Office Action Summary	Application No.	Applicant(s)	
	10/560,244	KASHIHARA ET AL.	
	Examiner	Art Unit	
	KARL I.E. TAMAI	2834

DETAILED ACTION

Fujita figure 1.

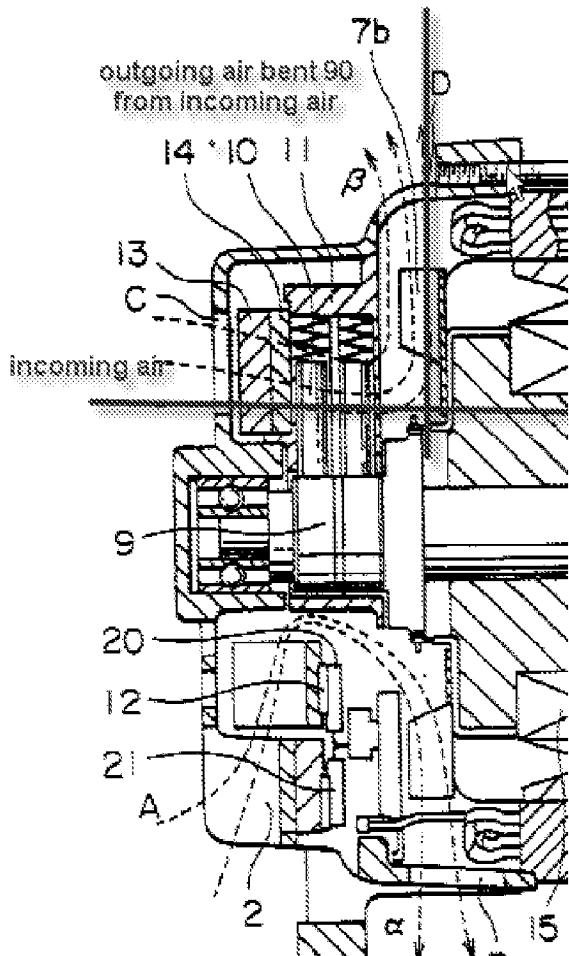
5. Claims 1, 4, and 7 are rejected under 35 U.S.C. 103(a) as being unpatentable over Fujita et al. (Fujita)(US 2002/0043886) and Oohashi et al. (Oohashi)(US 2003/0015932). Fujita teaches a generator for a vehicle having a rotor 6 with a field windings 15, a stator including a stator core 17 arranged opposed to the rotor and an electrical conductor wound 18 on the stator core, and a housing 3 supporting the rotor and the stator. Fujita teaches the stator core 17 is constituted by core having a plurality of slots (see figure 3) each extending to an axial direction, the electrical conductor is comprised of a rectangular slot-in portion 18a located in the slots and a circular cross-over portion 18b connecting each of the slot-in portions at the shaft end side of the stator, wherein the conductor 18 is formed so that of-the slot-in portion 18a located in the slots is molded to substantially rectangular (in the press dies 102a, 102b of figure 14) in its cross-sectional profile before it is entered in the slots and the conductor of the cross-over portion 18b is substantially circular in its cross-sectional profile. Fujita teaches longer side portion of the conductor (radial side) of the slot-in portion located in the slots has an insulation coating of which thickness is smaller than that of insulation coating in the cross-over portion due to the insulating resin coating of embodiment 9 (figure 12). Fujita teaches the longer side being in the radial direction and shorter side in the circumferential direction in order to increase output by reducing the chances of magnet saturation. Fujita teaches the core 17 directly connected to the housing 3 being endbrackets 1, 2 (see figure 1) protecting the conductors. Fujita teaches the blades bending the incoming air at a right angle (see figure 1, as annotated and shown below). Fujita teaches every aspect of the invention except it does not teach the core being

laminated or the conductor being a previously coated wire with the in-slot portion being substantially rectangular with the longer side having an insulation thickness smaller than the circular cross over portion and positioned in the slot with the long side in the radial direction without any air space. Oohashi teaches the core 11 being laminated for easy insertion of the winding 60 (paragraphs 0035-0036) with a rectangular cross section at the in slot portions 16 and circular cross over portions 17. Oohashi (embodiment 7) teaches the rectangular portions are molded by pressing in a jig to provide good space factor (paragraph 0008), the previously coated insulation 14 is compressed to be thinner than the round end sections (shown in figures 23A and 23B). Oohashi teaches the flat surfaces on the sides of being in close contact with the side walls of the slot to dissipate heat though the core (paragraph 0165). It would have been obvious to a person of ordinary skill in the art at the time of the invention to construct the alternator of Fujita with the stator core being laminated to provide easy assembly with a superior rate of production, as taught by Oohashi, and with the conductor being a previously coated wire with the in-slot portion being substantially rectangular with the longer side having an insulation thickness smaller than the circular cross over portion to provide good space factor, as taught by Oohashi, and with flat sides being in contact without any air space to effectively dissipate heat through the stator core as taught by Ooashi.

Claim 7: Fujita et al. discloses a stator and conductor as in claim 1 above and further discloses that the crossover portion is shielded by a case comprising of aluminum frames (Fig. 1 and [0103]). This is equivalent to the metallic housing as claimed in the instant application.
